CITY OF HANOVER
PLANNING COMMISSION MEETING
OCTOBER 26, 2015

Memorandum

RE: Greenhouse – 10875 Settlers Lane North

The City has received applications for a Conditional Use Permit, amendment to existing Planned Unit Development and site plan.

1 / 1.1 SITE PLAN
1" = 20'-0"

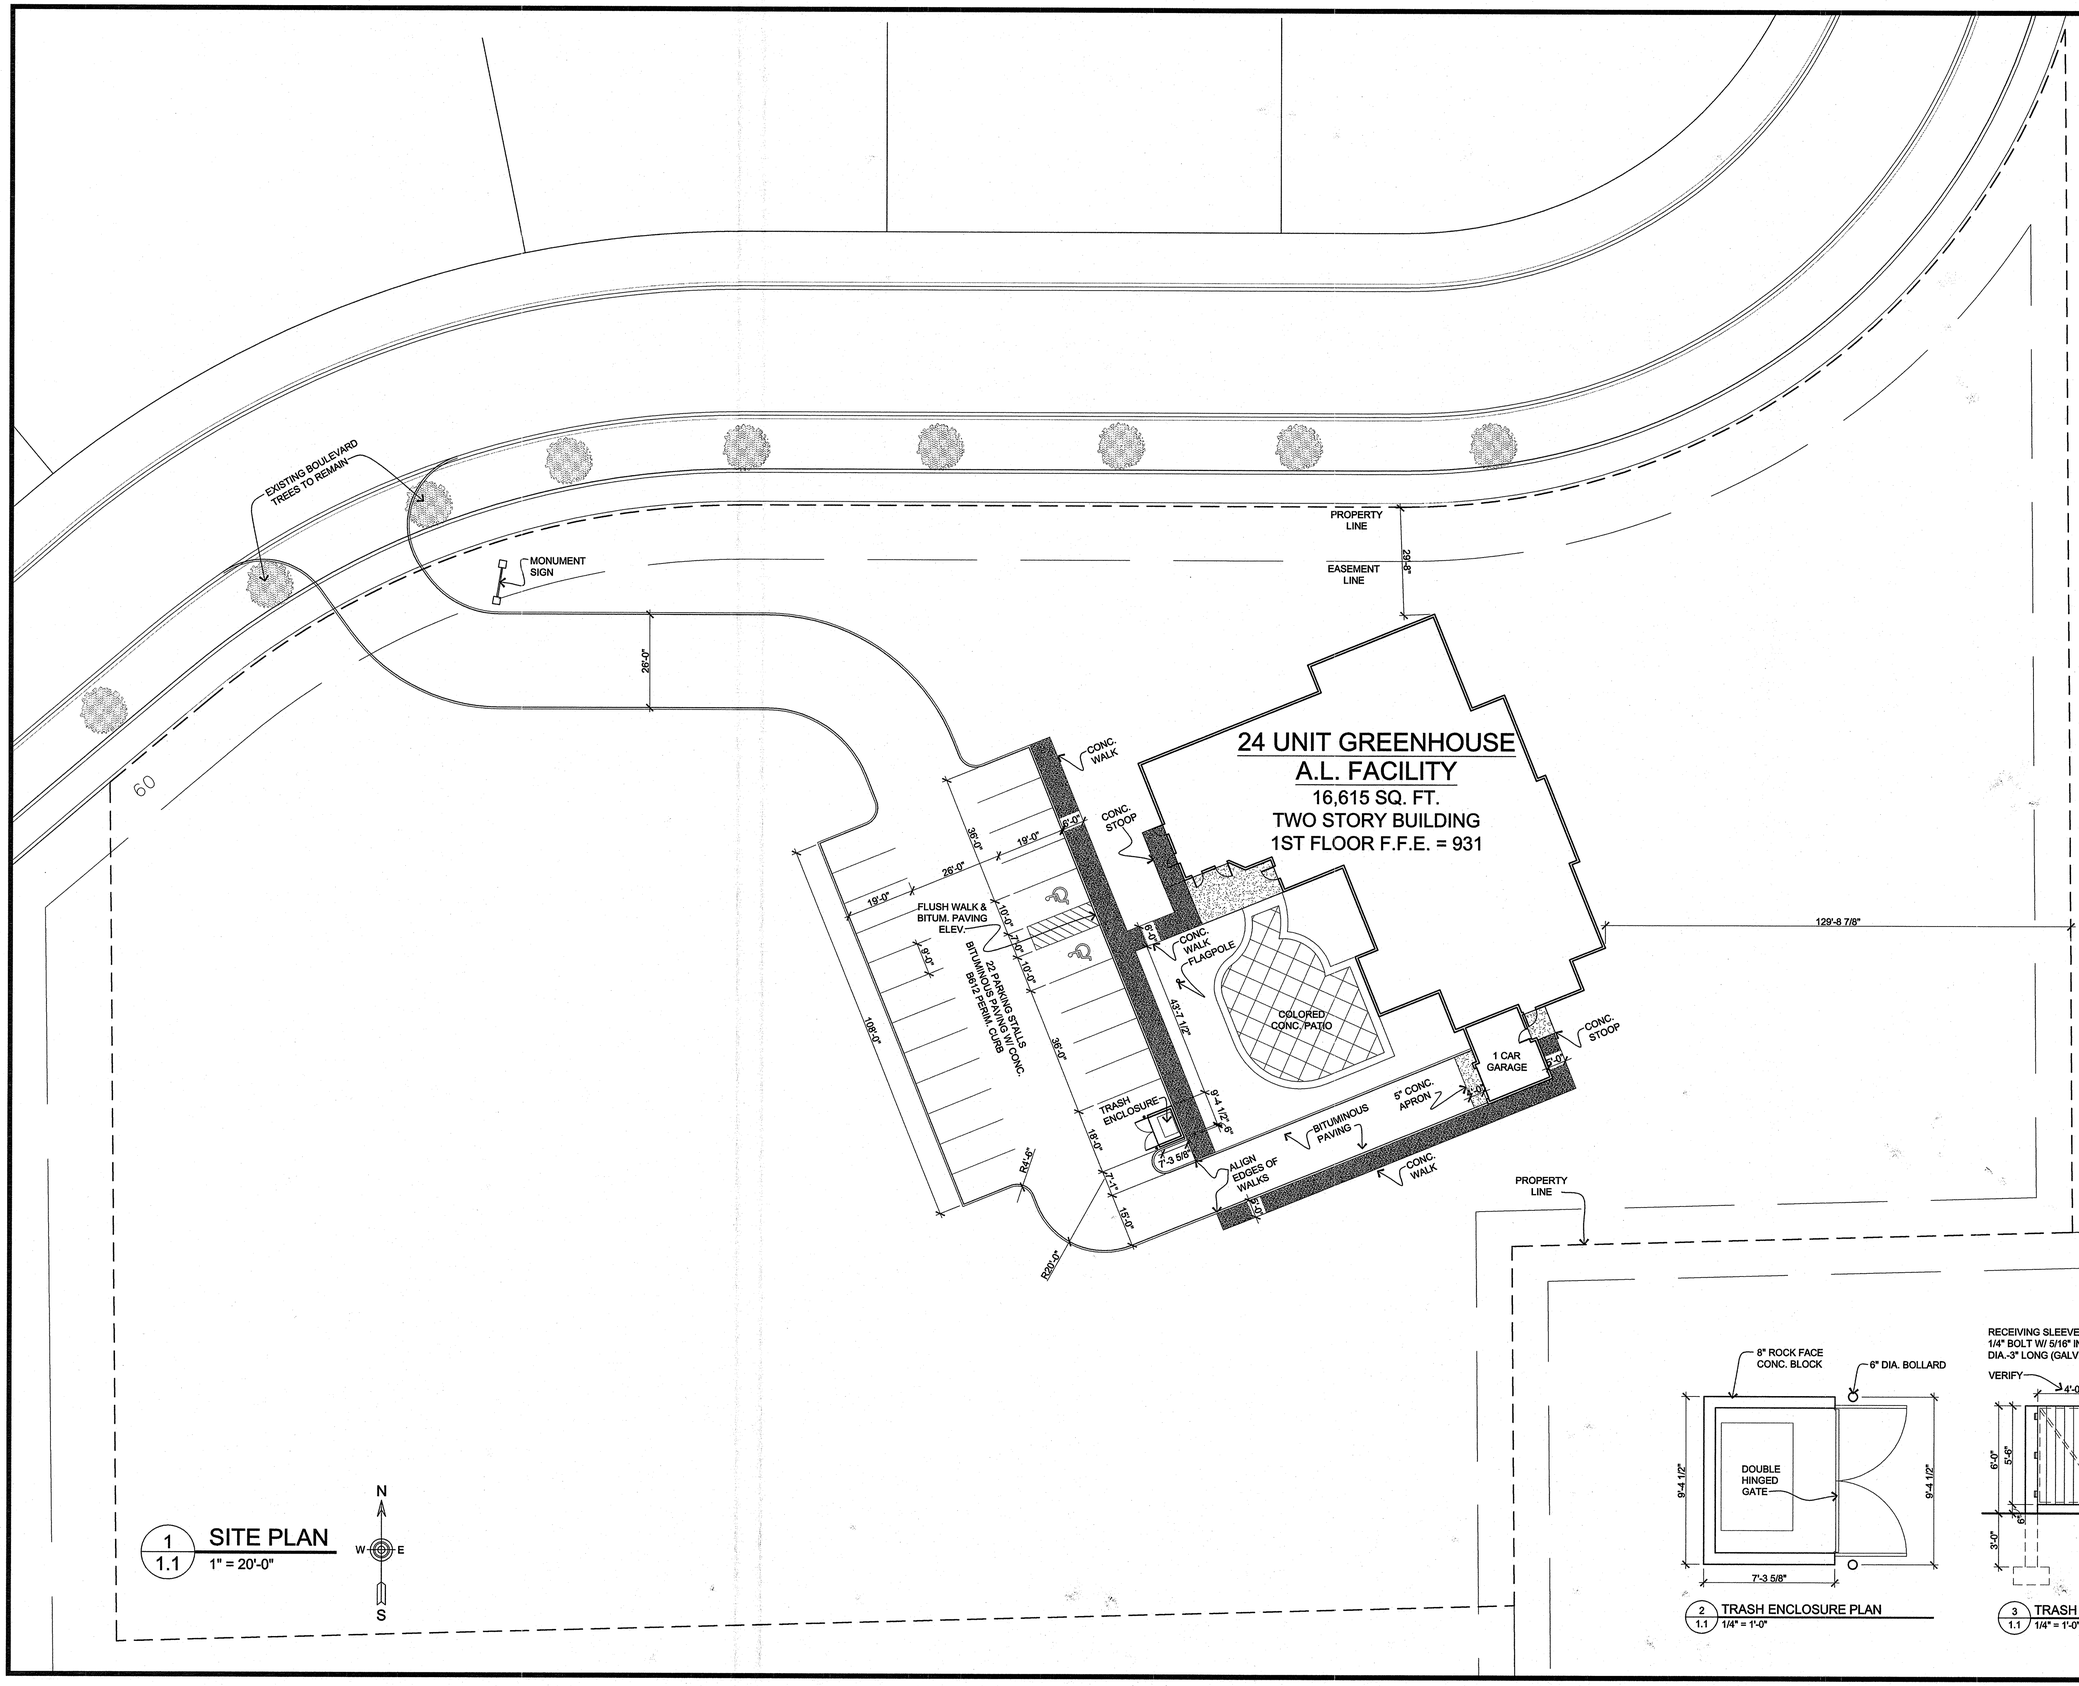
1. An 8 foot bituminous trail meeting City standards shall be constructed on Outlot H, Bridges of Hanover in locations that are adjacent to Lot 40, Block 8, Bridges at Hanover at the sole expense of the Developer. Plans shall be prepared by the Developer and submitted to the City Engineer for review.

2. The site plans for the project shall be amended to show the following:

a. A sidewalk from the building to the trail.

b. A landscape plan showing the location, species, and size of all plant materials shall be submitted for the review and approval of the Planning Commission.
